DOCUMENT CHANGE REQUEST

DCR number 634	Changes required for: N/A	Originator: Samuel SAVIN
Date: 2011/06/16	Date sent: 2010/11/23	Organisation: CNES
Status: IMPLEMENTED

Title:	Diodes Silicon Switching, based on types 1N6639, 1N6640 and 1N6641		
Number:	5101/027	Issue:	1

ESCC Detail Specification No. 5101/027

1.7.1 Leadless Chip Carrier Package (LCC2D) - 2 Terminal

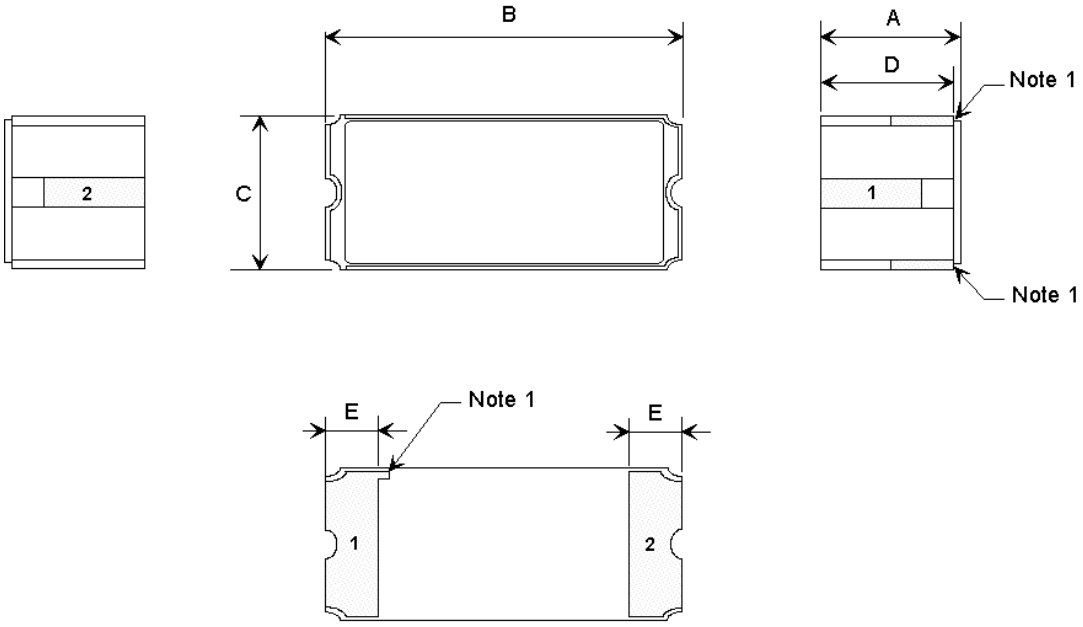
Variant 07: new ST variant introduction with LCC2D package
Variant 08: new ST variant introduction with LCC2D package

1. Terminal identification: The anode is identified by metallisation in the two castellations and by the index mark on the bottom metallisation.
2. For Variant 08 dimension limits apply prior to solder coating of terminals.

FIGURE 1 – PARAMETER DERATING INFORMATION (Not Applicable for the variants 07 to 08)

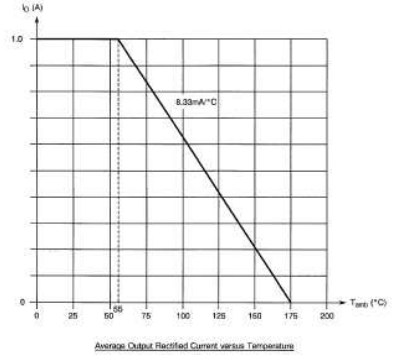
b) Removal of any redundant paragraphs and information,
e.g.: Figure 1; mechanical paragraph; Figures 4, 5(a), 5(b); Appendix A for MICROSEMI/I

Justification .
Variant 07: new ST variant introduction with LCC2D package
Variant 08: new ST variant introduction with LCC2D package

Figure 2(c)- Variant 07 to 08 - Leadless Chip Carrier 2 (LCC2D) – 2 Terminal

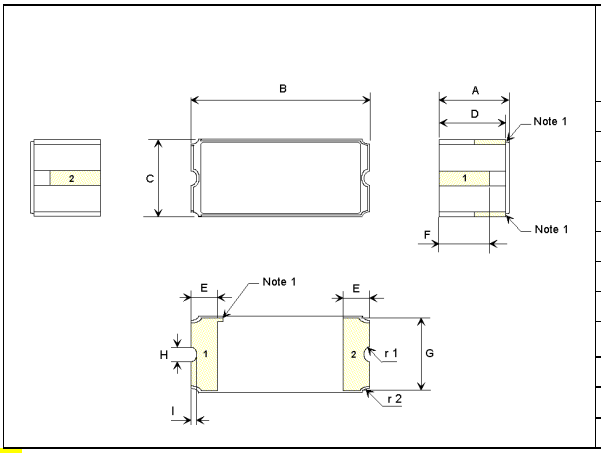
Justification .
Variant 07: new ST variant introduction with LCC2D package
Variant 08: new ST variant introduction with LCC2D package

Notes:
1- The anode is identified by a metallization in 2 top angle castellations and by the index mark on the bottom metallization n° 1.
2- Measurement prior to solder coating the mounting pads on bottom of package.
